Sydney Olympic Park New High School

SSDA Architectural Design Report

Amendment Report Addendum

Site Plan Comparison

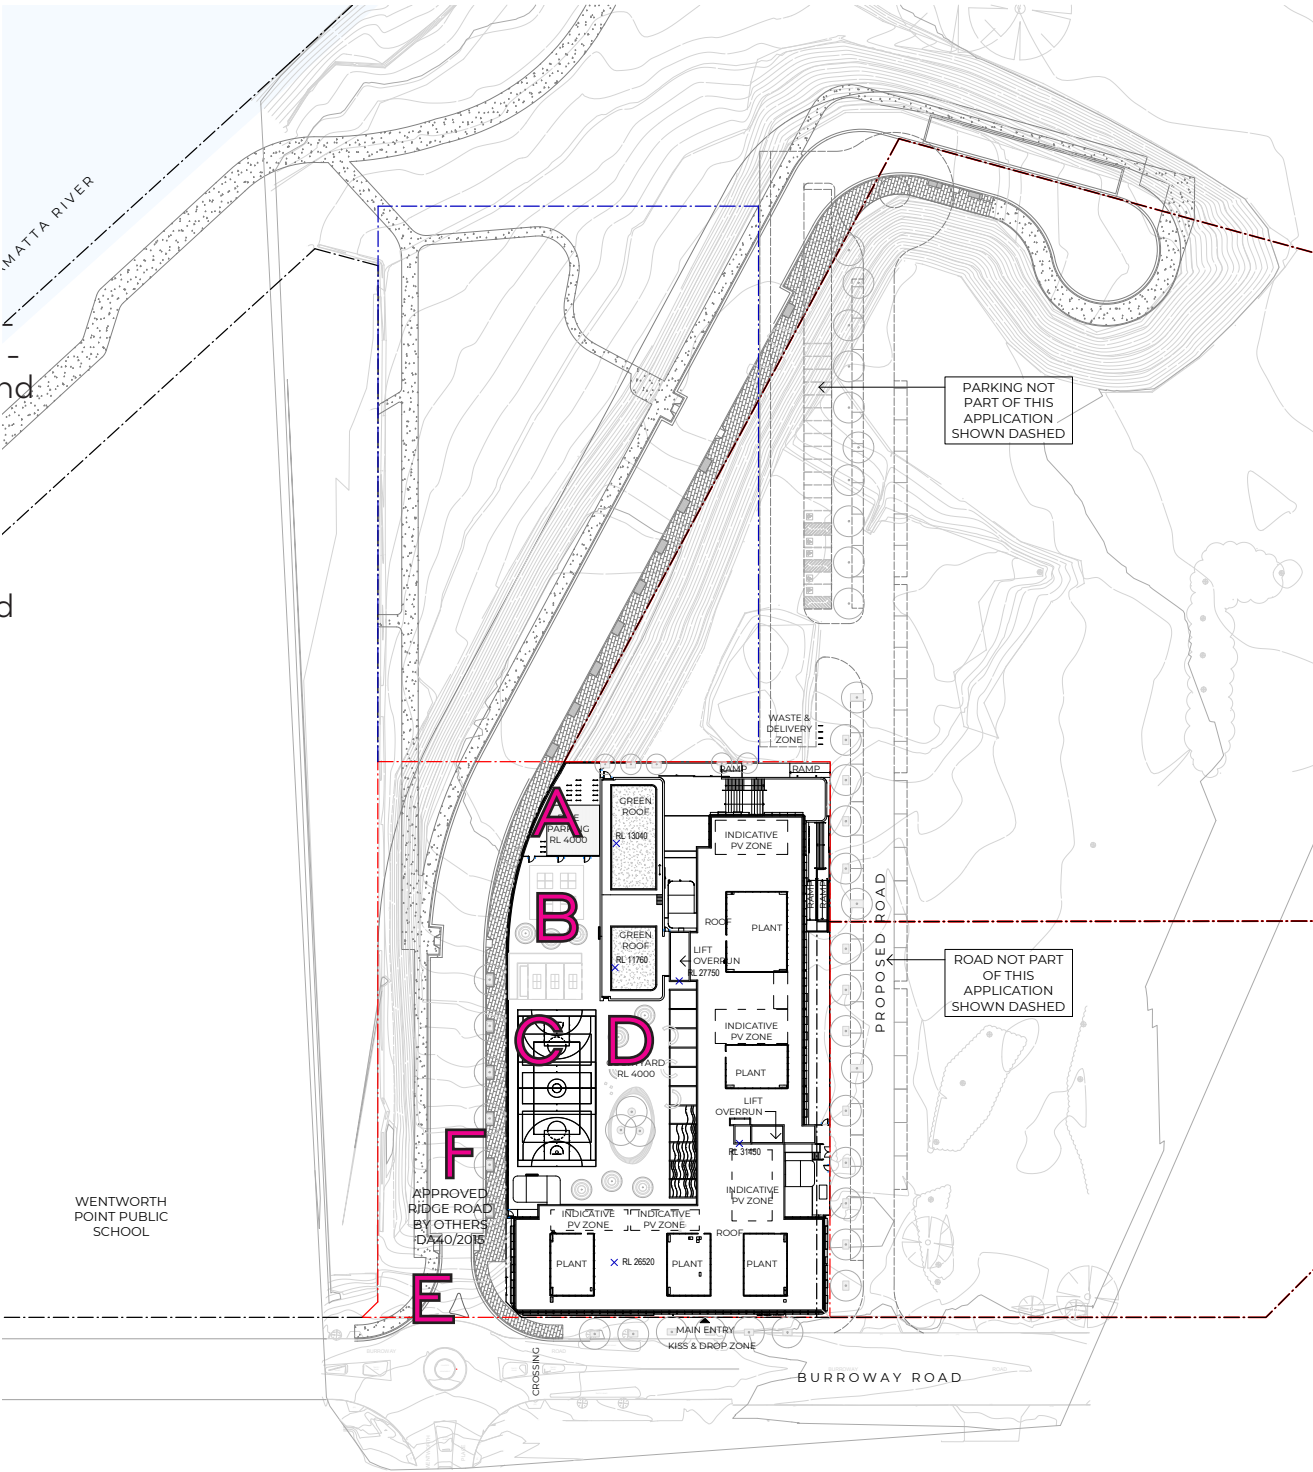
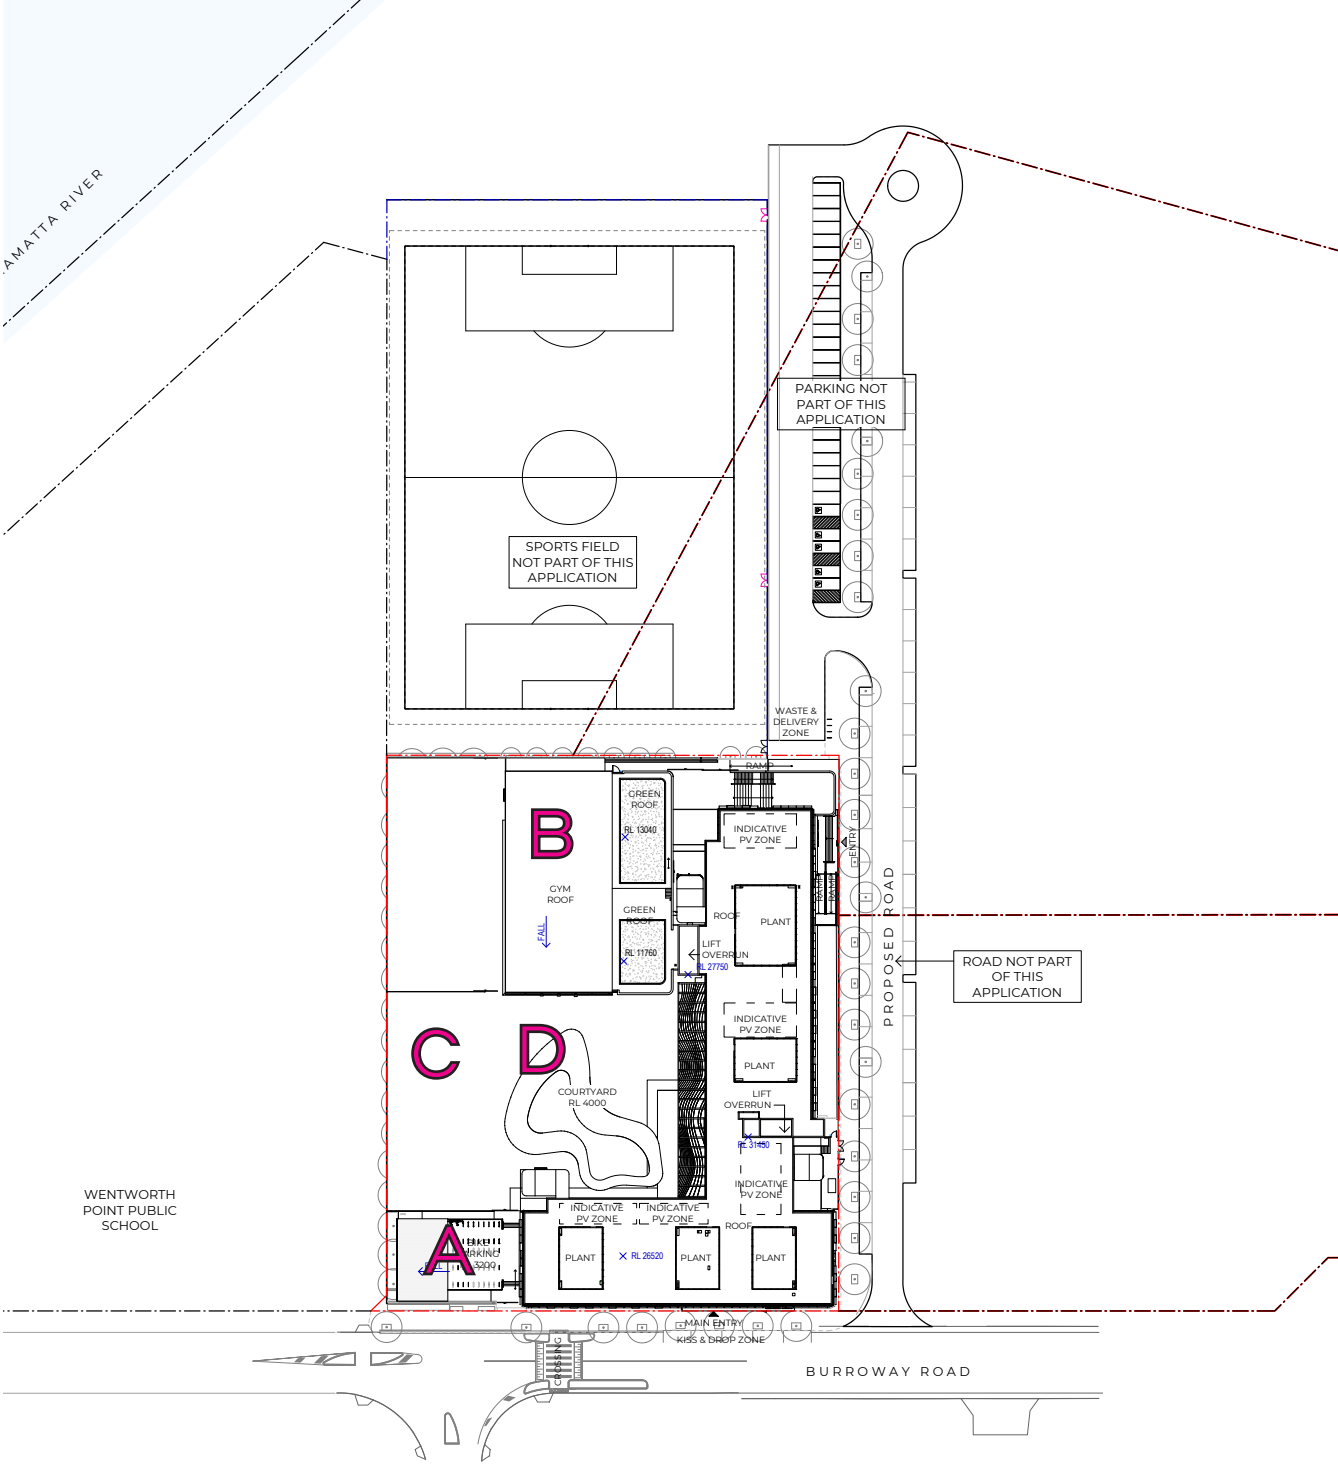
- A** Bike parking relocated
- B** Ground floor hall removed - relocated to Level 1
- C** External multi-purpose court - reduced to 1 and relocated
- D** Courtyard redesign, canopy omitted
- E** Ridge Road added
- F** Additional egress added to Ridge Road

Ground Floor Plan Comparison

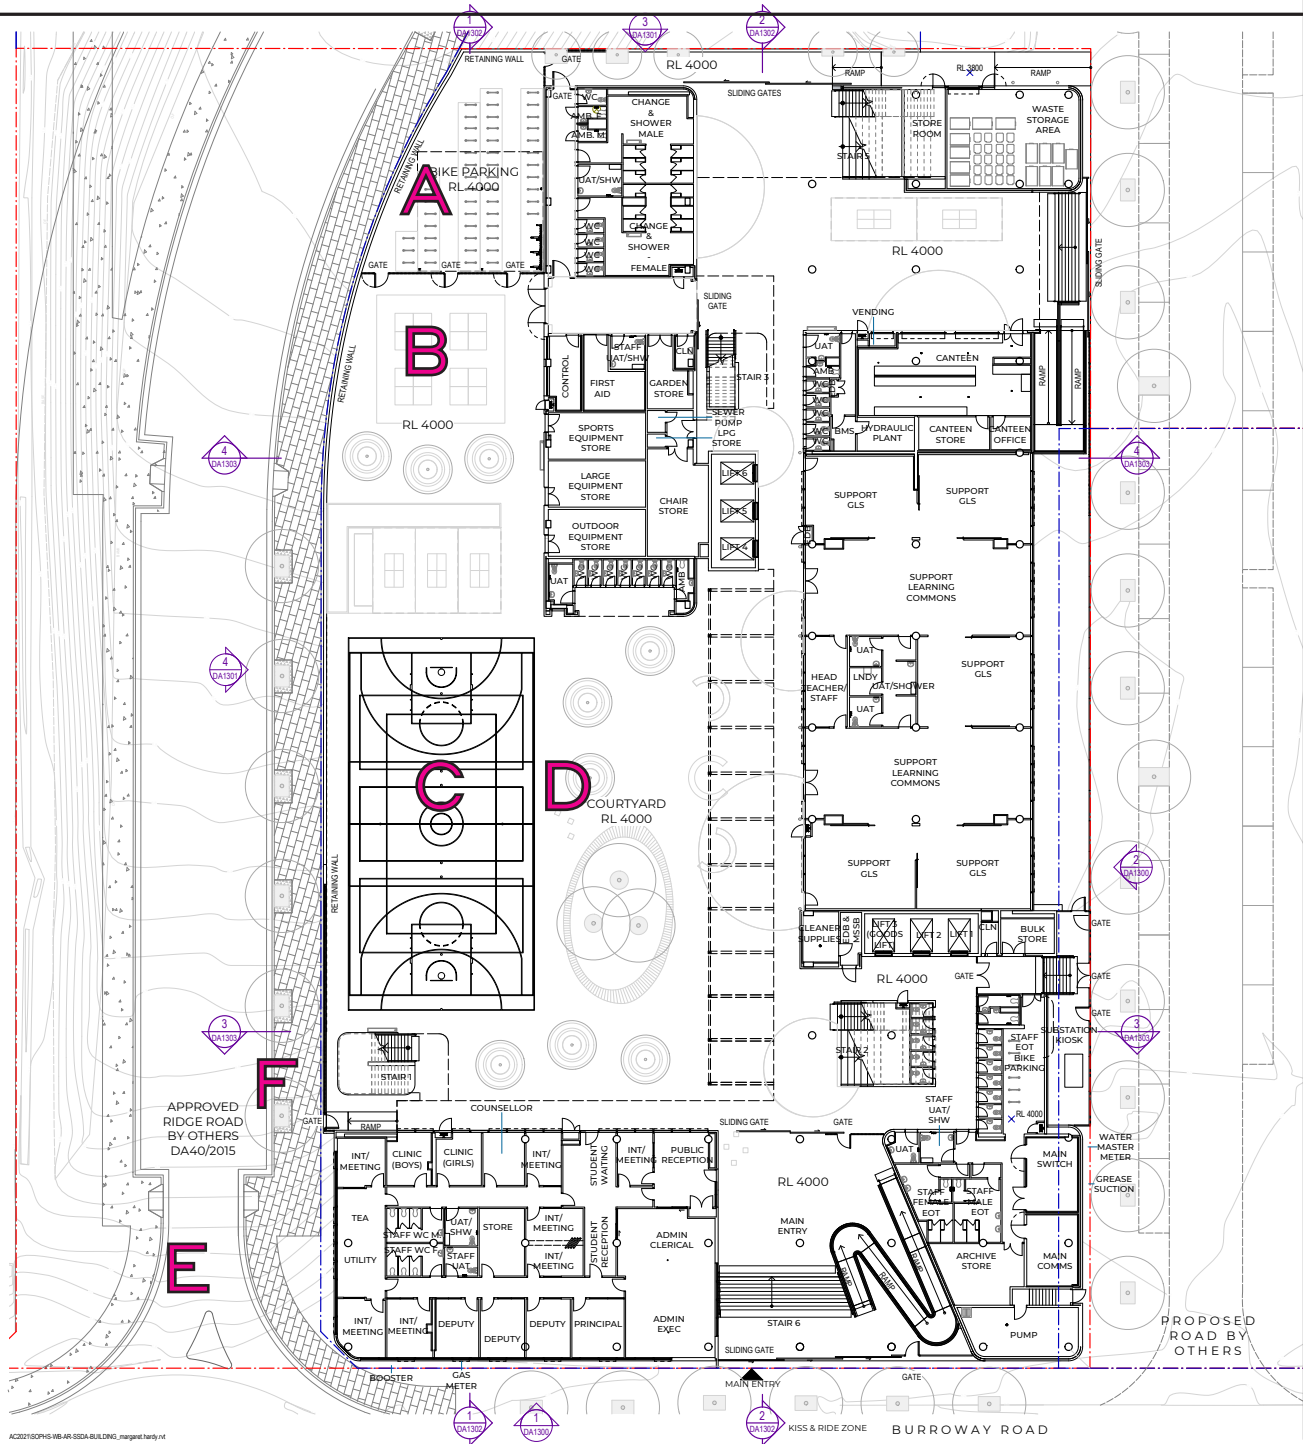
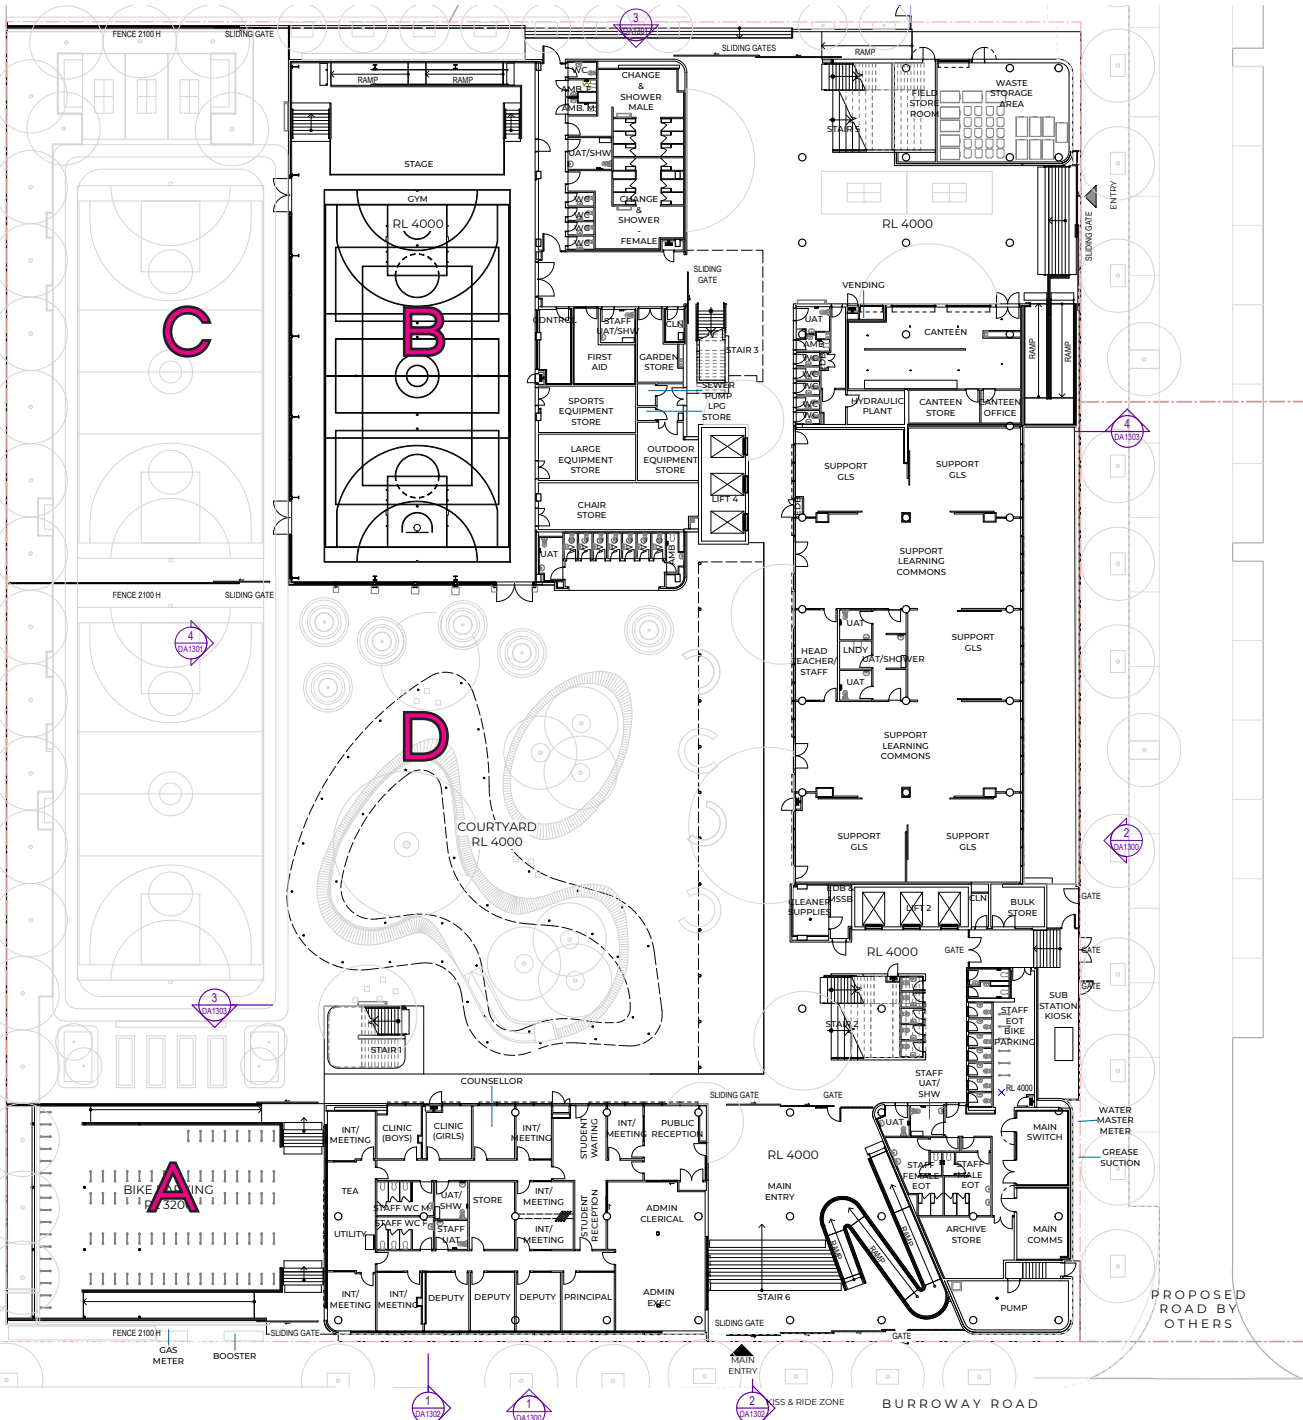
- A** Bike parking relocated
- B** Ground floor hall removed - relocated to Level 1
- C** External multi-purpose court - reduced to 1 and relocated
- D** Courtyard redesign, canopy omitted
- E** Ridge Road added
- F** Additional egress added to Ridge Road

Level 01 Floor Plan Comparison

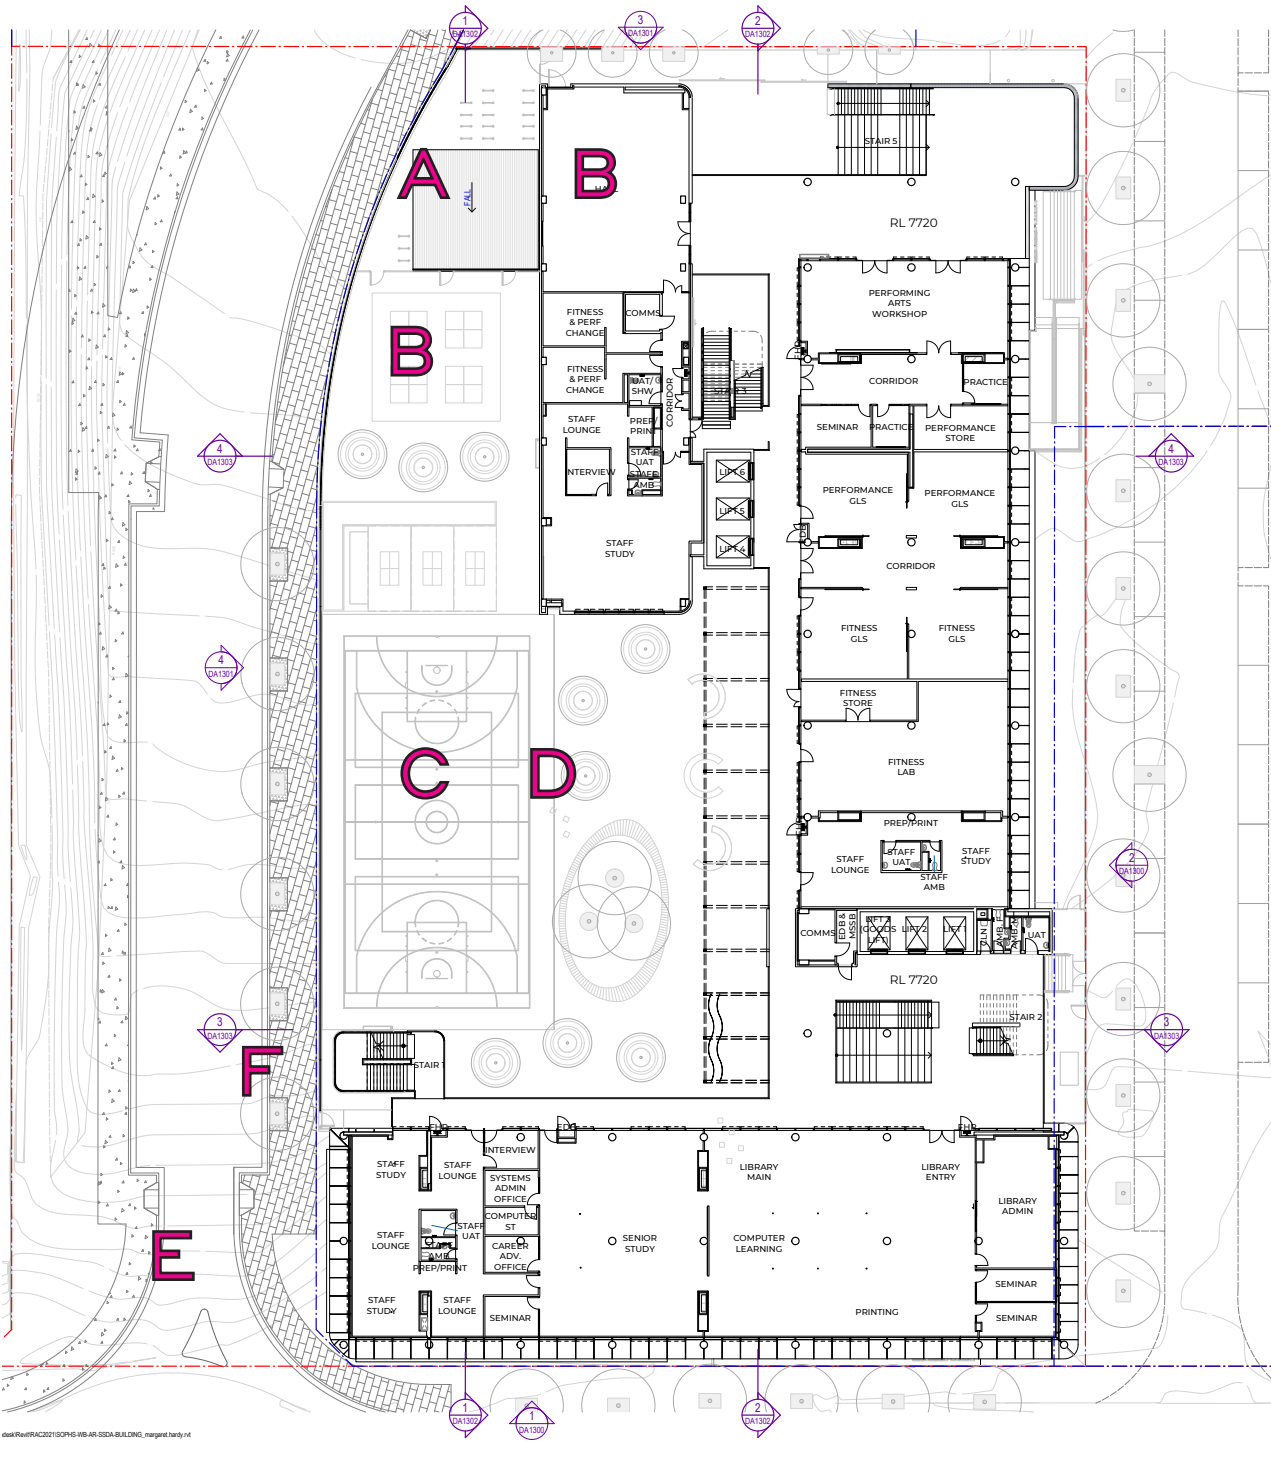
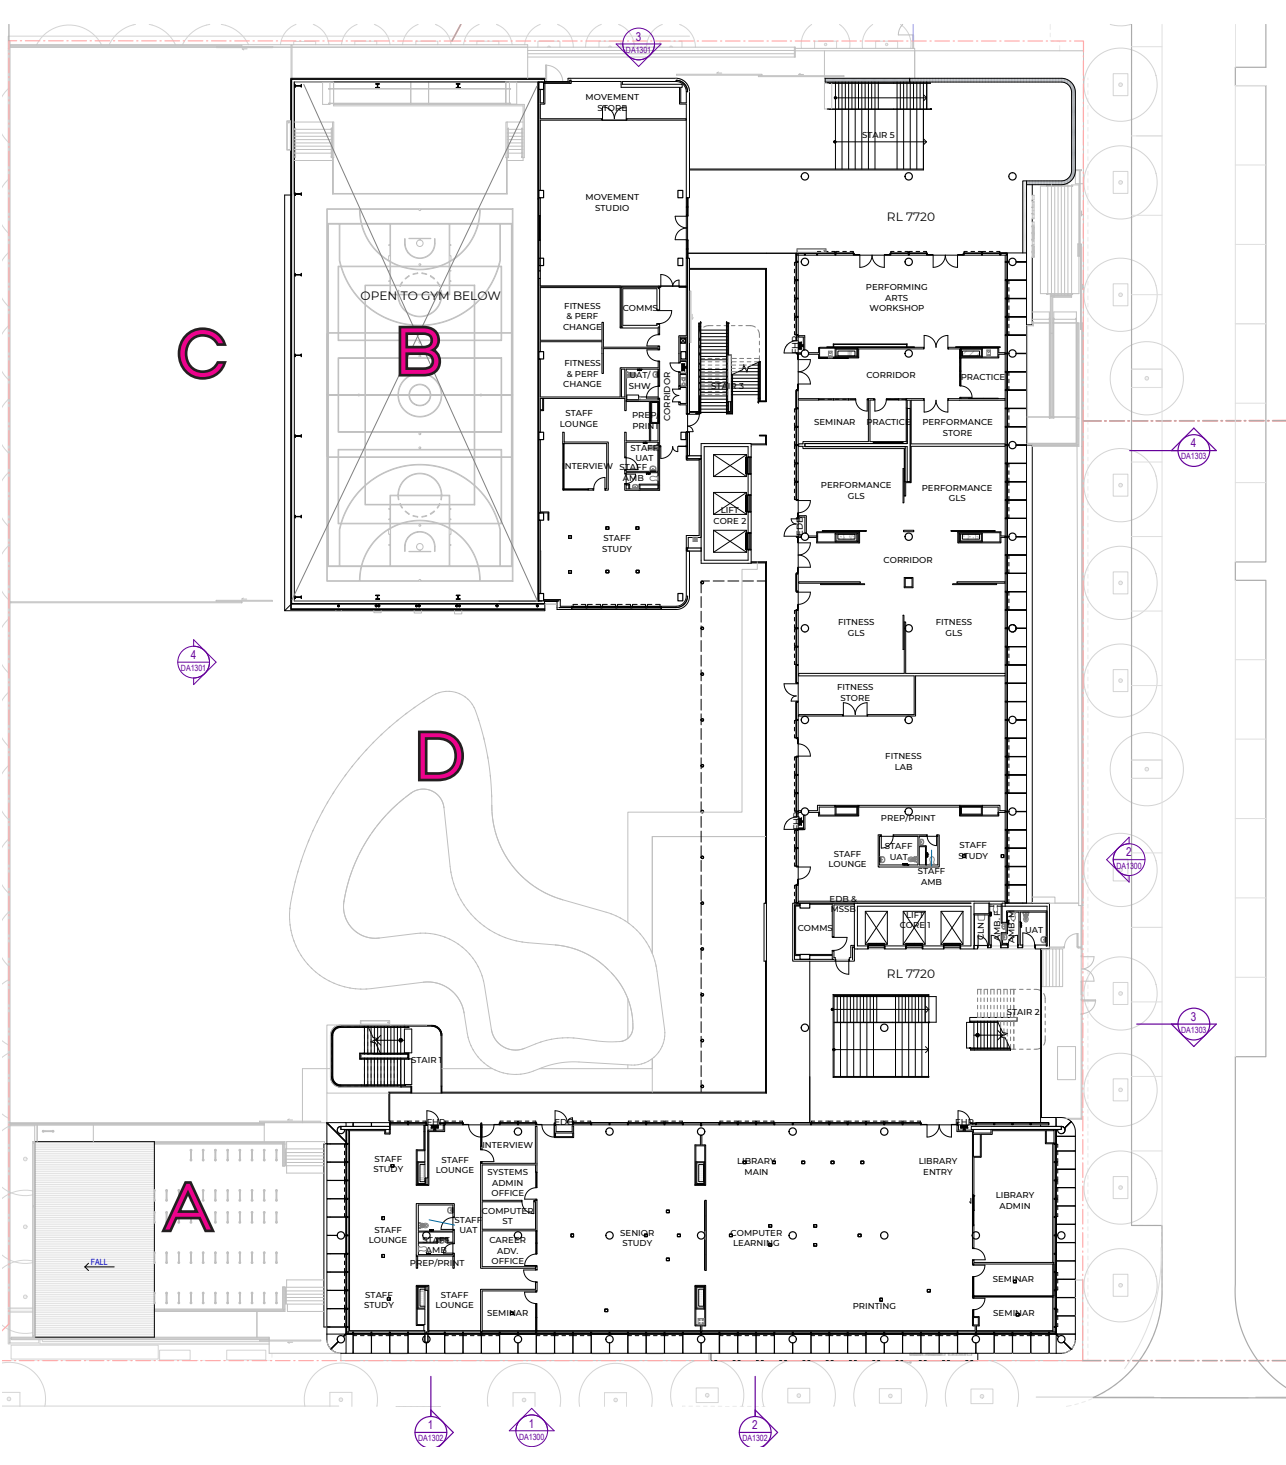
- A** Bike parking relocated
- B** Ground floor hall removed - relocated to Level 1
- C** External multi-purpose court - reduced to 1 and relocated
- D** Courtyard redesign, canopy omitted
- E** Ridge Road added
- F** Additional egress added to Ridge Road
